Product code: CS22t-60b

Description: LMP chassis AW compatible EVO6 (rev. 3)

New product / replacement: Replaces CS22t-60

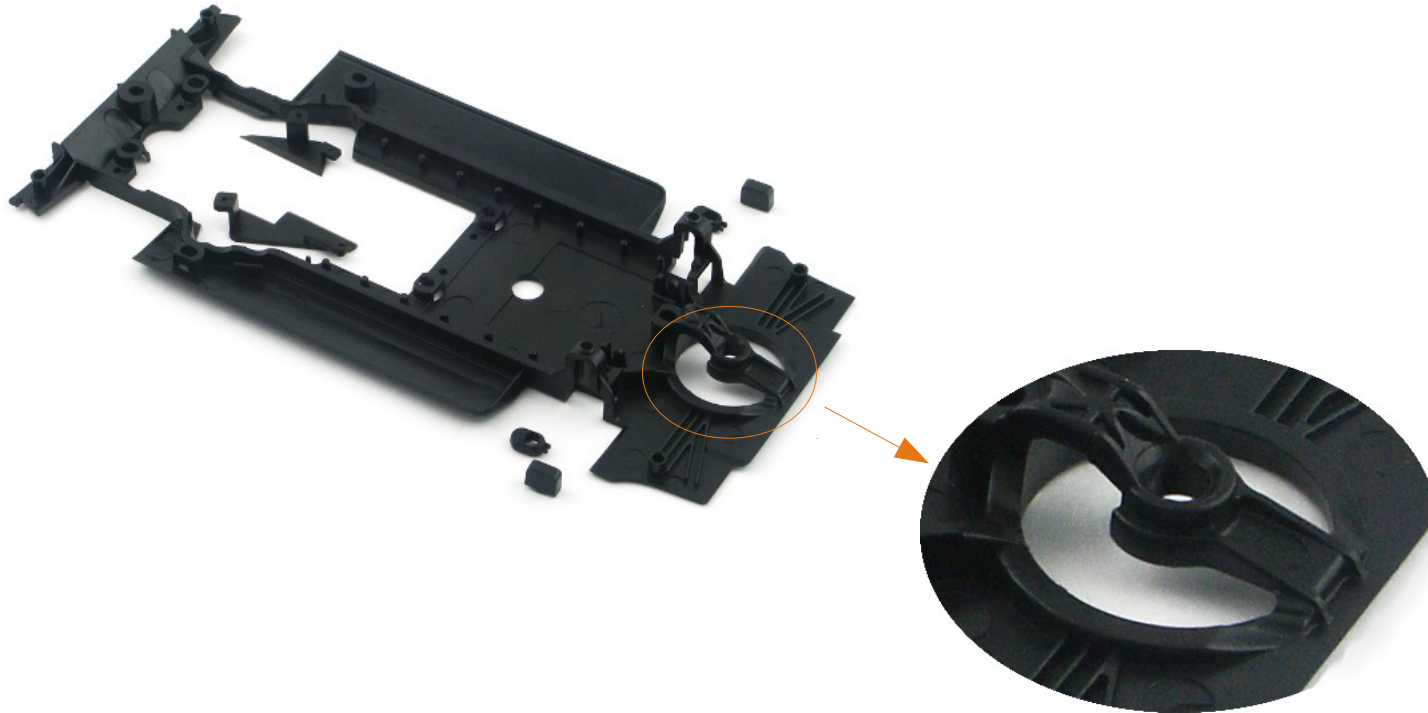
Difference from replaced item: Improved pickup zone (larger cable clearance)

- Spare chassis for Lola LMP models.
- Improved pickup zone to make easier the connection with cables:
 - Less risk of contact between body and cables.
 - Cables help to straighten pickup after corners.
